Mid-Region Metropolitan Planning Organization

Date: June 6, 2013

RE: **MPO Staff Recommendation and Findings
Roadway Access Policies Change Request from City of Albuquerque for
Volcano Heights Sector Plan Area**

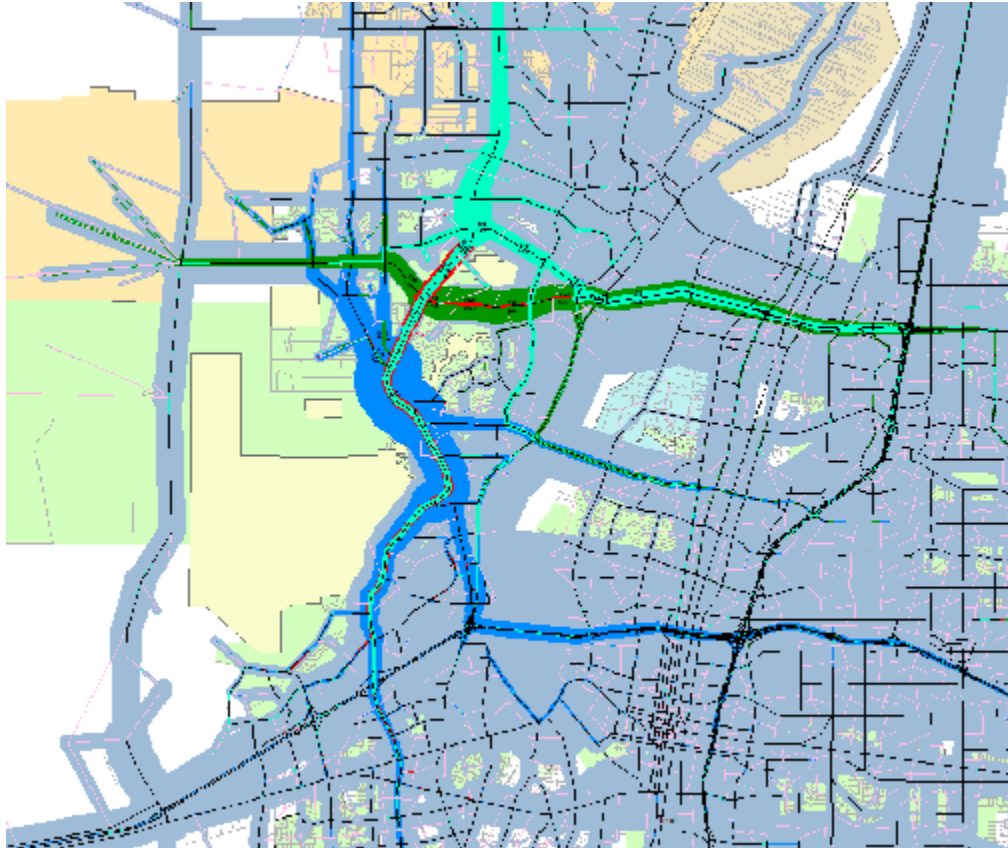
- Because it is consistent with the 2035 MTP, the modeling scenario presented here does not create the level of access that the VHSP call for.
- Select-link analysis from the travel demand model was used with several locations within and adjacent to the VHSP area being selected to identify “travel markets” in the vicinity of the project area.

- There is a predominant east-west travel pattern along Paseo del Norte with many trip origins from the west of the VHSP area associated with travel flow to destinations located to the east and south.

- Trips using Unser Blvd in the immediate VHSP vicinity between Paradise Blvd and Paseo del Norte demonstrate a predominant north-south travel pattern.

FIGURE 1: Scheme A – Original Roadway Network

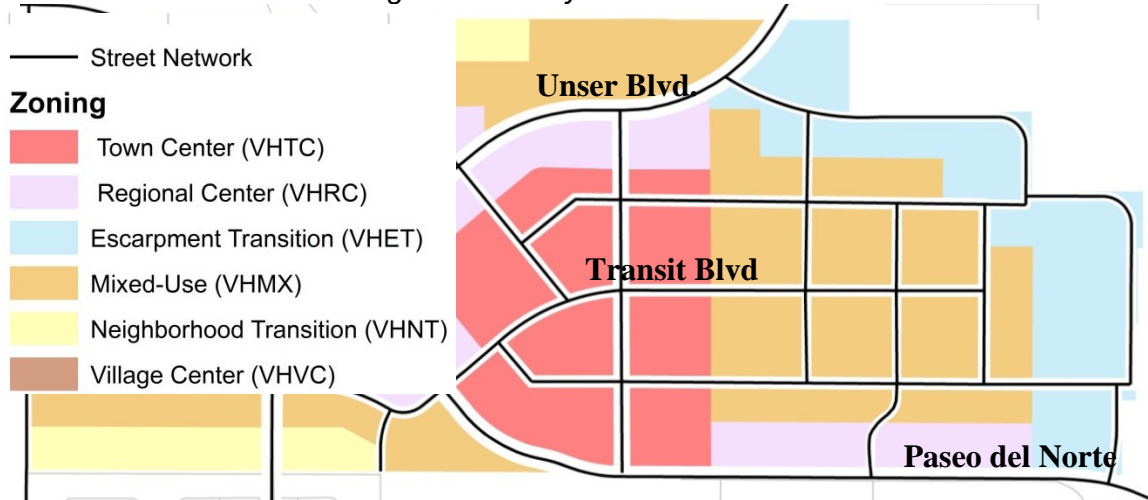
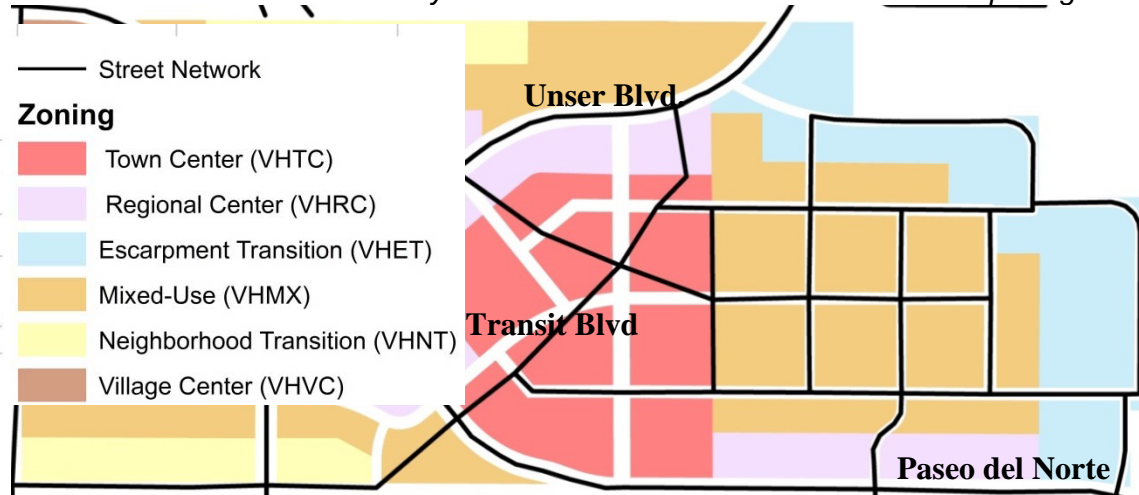
The Transportation Accessibility Model (TRAM) was used to compare pedestrian accessibility between the original roadway network in the Volcano Heights Sector Development Plan, loosely based on quarter-mile spacing between full access intersections and hereafter referred to as Scheme A, and a roadway network with half-mile full-intersection spacing with right-in, right-out intersections no less than a quarter-mile apart, hereafter referred to as Scheme B.

The following figures show the roads and intersections for Scheme A and Scheme B. In Scheme B, right-in, right-out intersections are located in between full-intersections. Although motor-vehicle traffic will only be allowed to make right-in, right-out maneuvers, it is assumed that pedestrians can use the intersection to make any desired crossing.

FIGURE 4: *Single Bus Rapid Transit Stop on Scheme A*

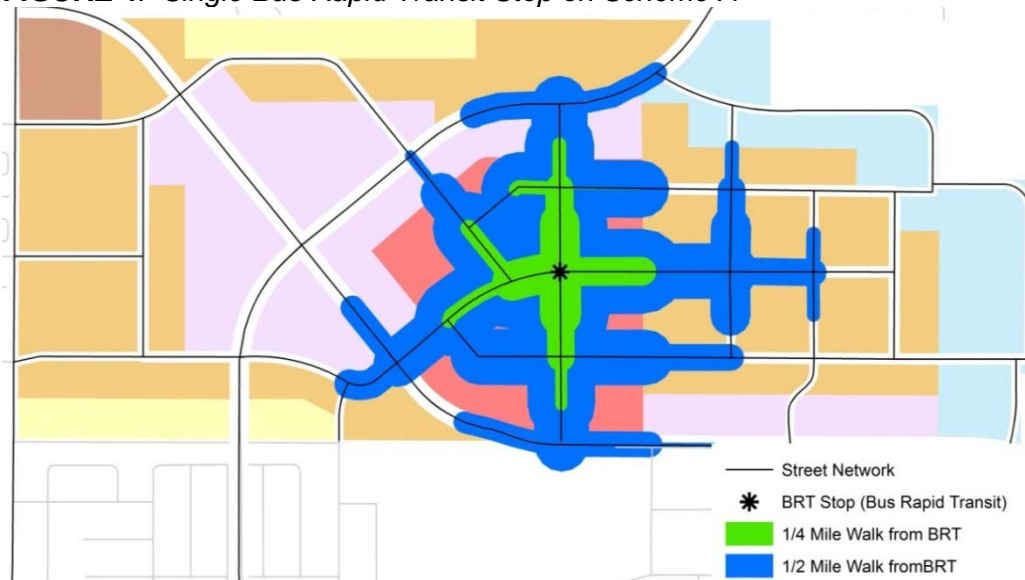
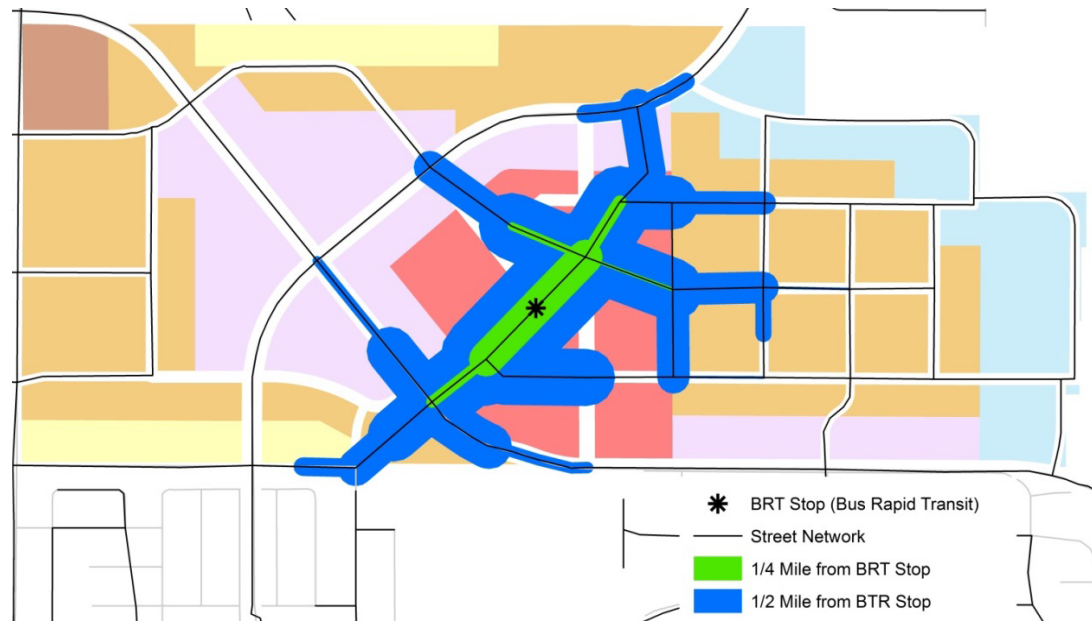
Scheme A provided very efficient access from a single, centrally located BRT stop, with 75% of the Town Center accessible within a half-mile walk. Scheme B provided access to 55% of the Town Center with a single stop. The differences were slightly smaller when the accessibility from two BRT stops was modeled. In this case, Scheme A provided accessibility to 85% of the Town Center within a half mile walk of either of the two stops, and Scheme B provided accessibility to 70% of the Town Center. There was an interesting downside to having two BRT stops in Scheme A. With the single, centrally located stop, the street network provided a round, center-like, accessible area versus an elongated, corridor-like accessible area that was created with two stops.

In this scenario a single bus rapid transit (BRT) stop was selected along the Transit Blvd. centrally located in the Town Center. Quarter-mile and half-mile walks are indicated from this stop. Scheme A and a centrally located bus stop provides an accessible area that is round or center-like as opposed to an elongated corridor.

FIGURE 6: Two Bus Rapid Transit Stops on Scheme A

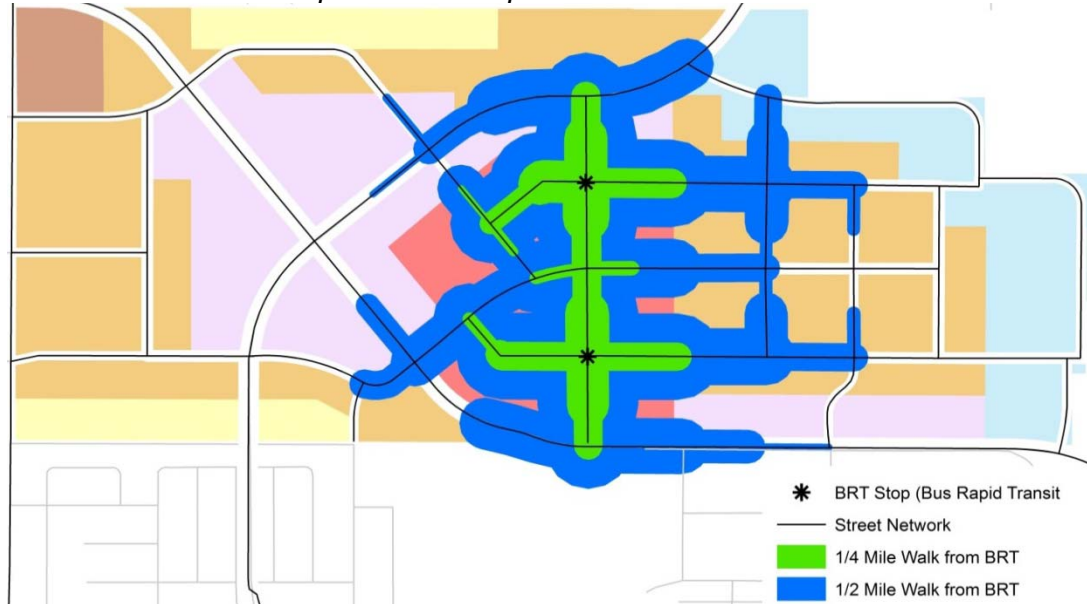
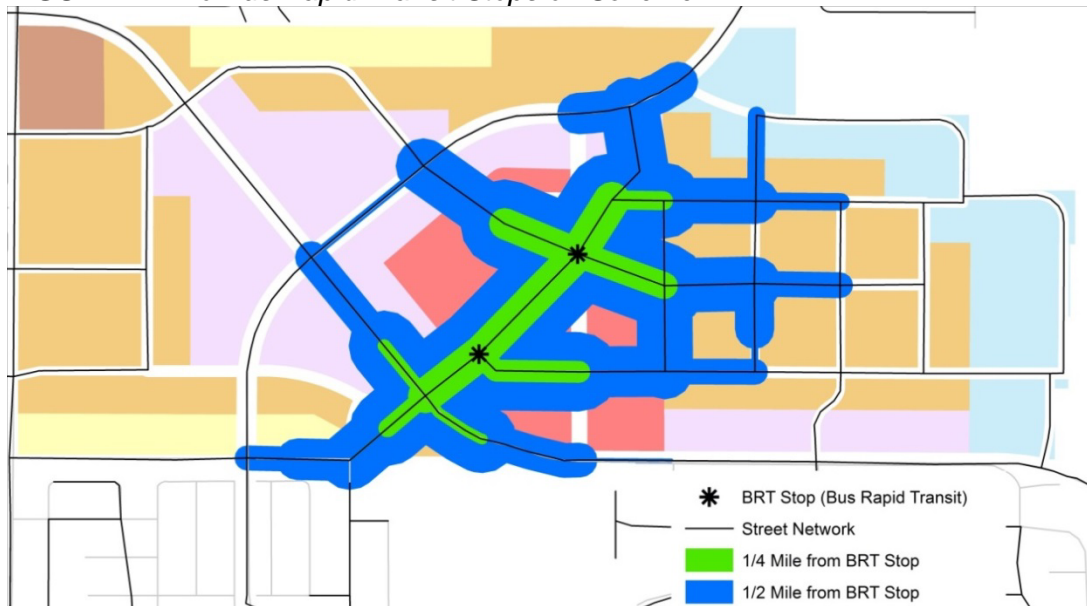
Although the single bus rapid transit stop provided good accessibility to the Town Center, a second bus rapid transit scenario was examined. Scheme A allows for the two stops to be located at intersections that are approximately a quarter-mile apart. Scheme B has two stops at intersections, but the spacing between the stops is a little closer at 1/5 mile.

FIGURE 10: Walking Access from West of Paseo del Norte and Unser on Scheme A

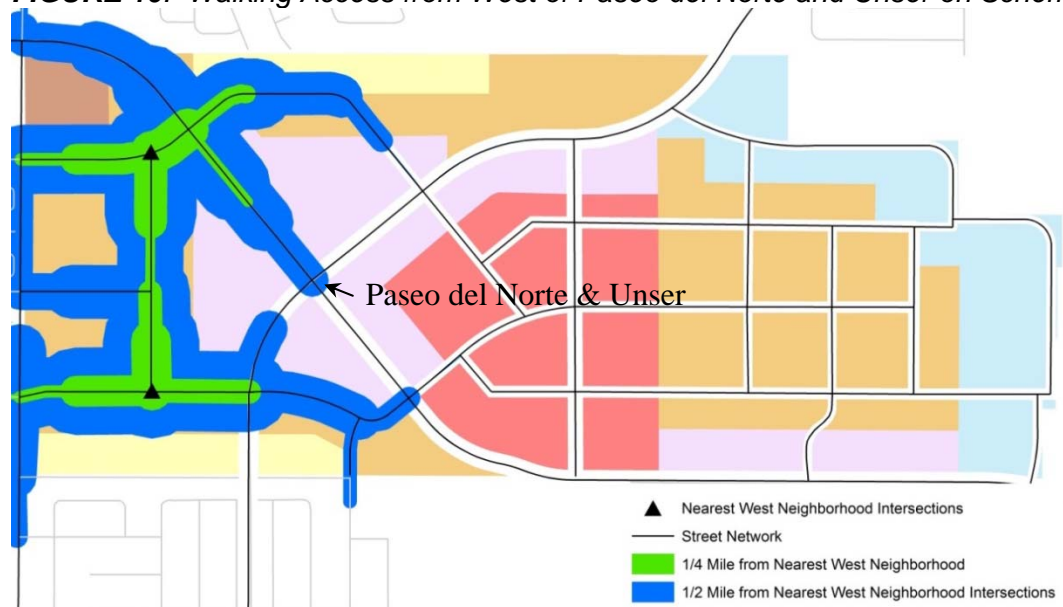
Neighborhoods west of Paseo del Norte and Unser have limited access to the Town Center for both networks. Both networks have the same roadway configuration northwest of this major intersection, and the Town Center is not accessible within a half-mile walk from the northern area. Scheme A has improved access from the southwest neighborhoods. The very edge of the Town Center is reachable within a quarter-mile walk from the southern area in Scheme A. Unfortunately, the trip west to Universe is too long in Scheme B to make travel east to the Town Center in a half-mile walk.

This scenario looks at neighborhood intersections physically closest to the Town Center. Often a large challenge occurs when homes are located relatively close to destinations, but the roadway network does not allow efficient access. Scheme A provides better access to the Town Center from neighborhoods southwest of Paseo del Norte & Unser.
